ELECTRIC POWER RESEARCH INSTITUTE

May 20, 1980

SUBJECT: Comments on Draft Volume 4 of NUREG-0460

### Analysis of the ATWS Assessment in NUREG 0460-IV

FIGURE 1: Probability of Exceeding Pressure Limit  
For a B & W Loss of Feedwater

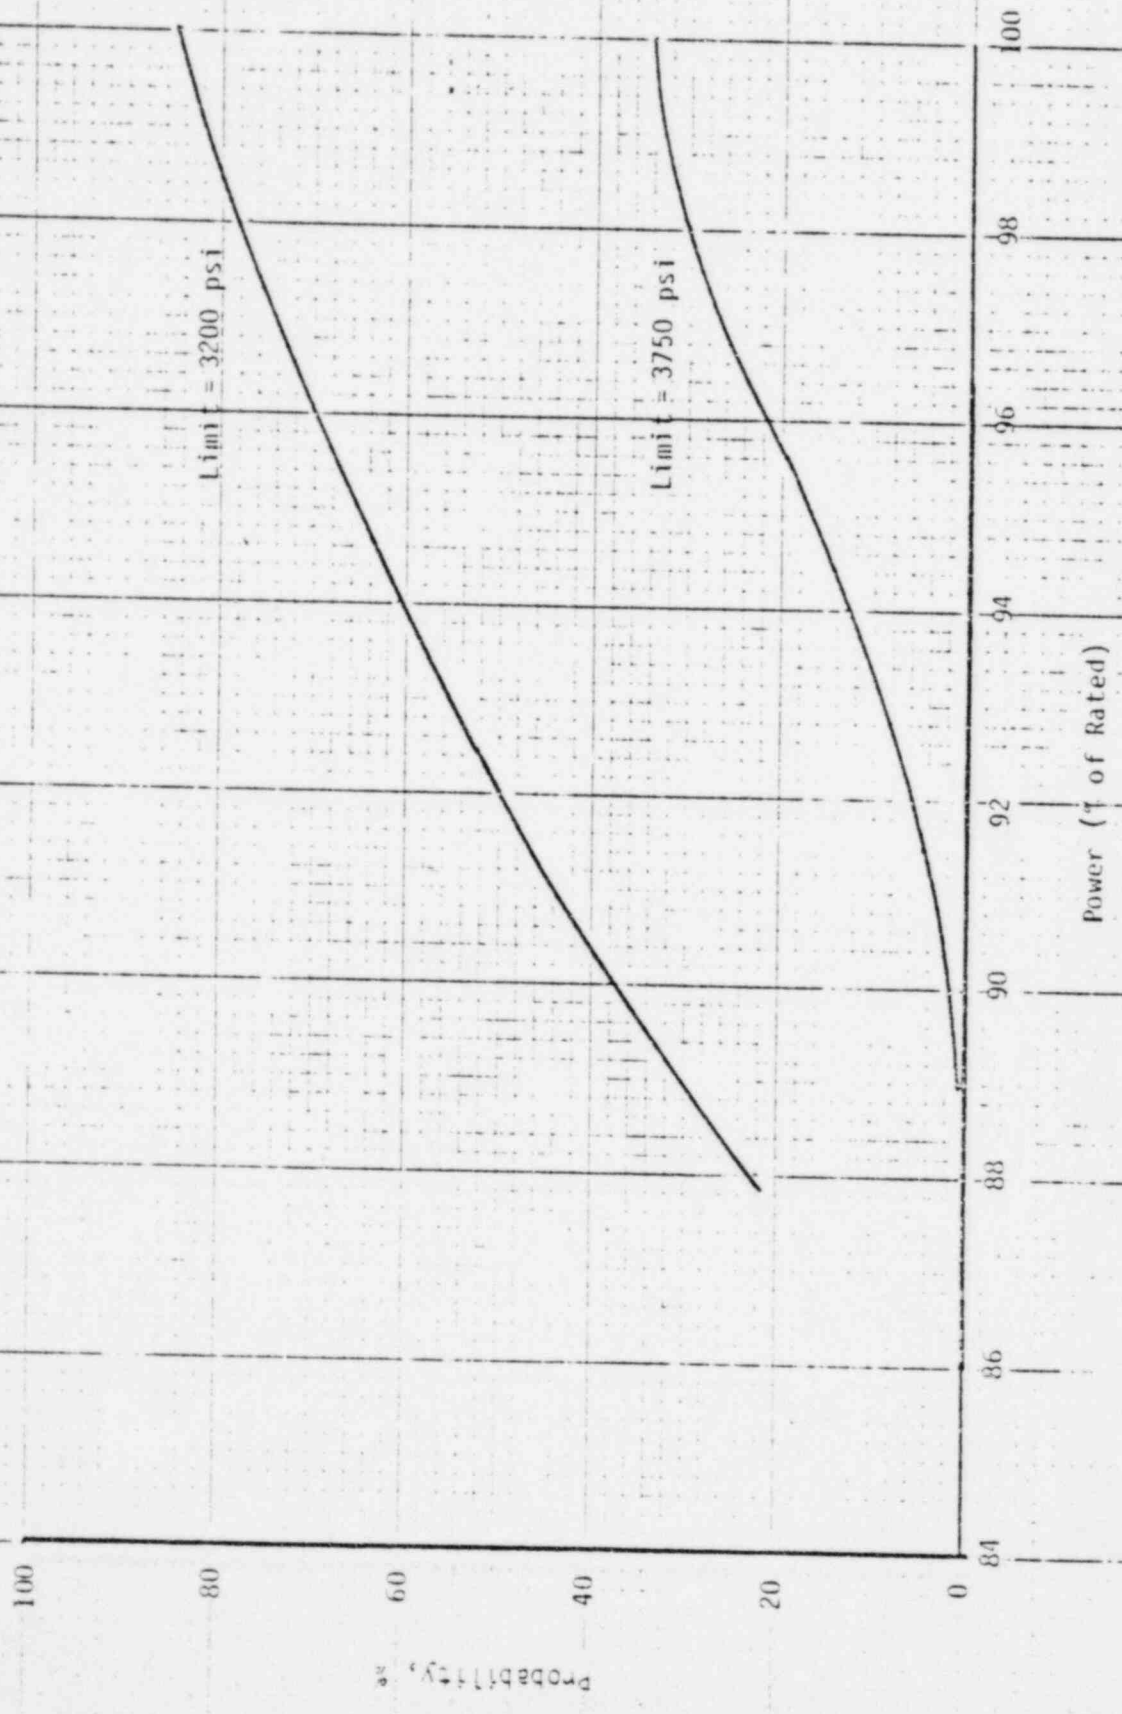
2. All reactor types are the same.

Although NUREG-0460 states that 8 transients per year apply to BWRs and 5 to PWRs, it does not break down the various PWR vendors or reactor types for a vendor. Given the detailed analyses done by the vendors over the years it is indeed possible to discriminate by vendor. This discrimination was done in EPRI NP-801 and the following tables (2,3) are reproduced from there. If one looks at the actual plant behavior for these events (Figure 2) one sees that the real behavior of plants varies significantly from that assumed by the staff.

Figure 1  
 ATWS Event Sequences During  
 the Fuel Cycle

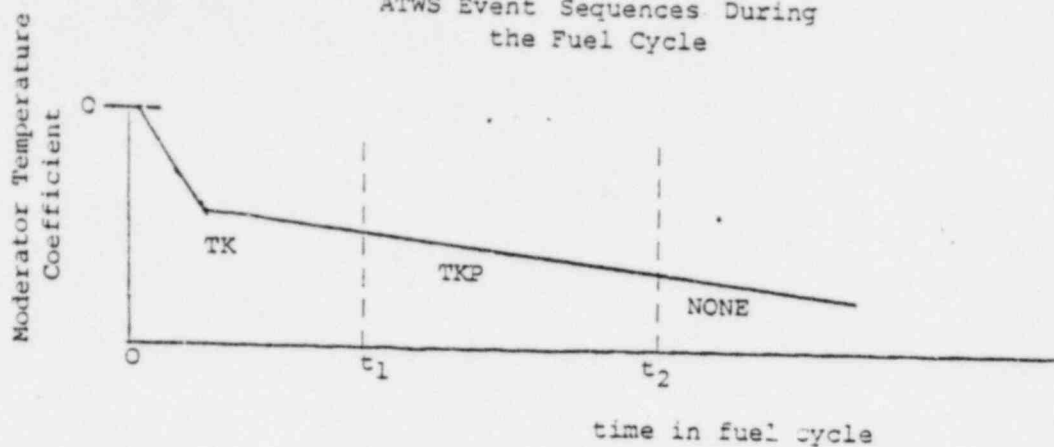
Estimate  $t_1$  to be greater than about 30% of the cycle time and  $t_2$  about 60%. For the very worst transients (total loss of feedwater),  $t_1$  may be about 50% and  $t_2$  may not apply. For our purposes we assume  $t_1$  to be 40% and  $t_2$  to be 80%.
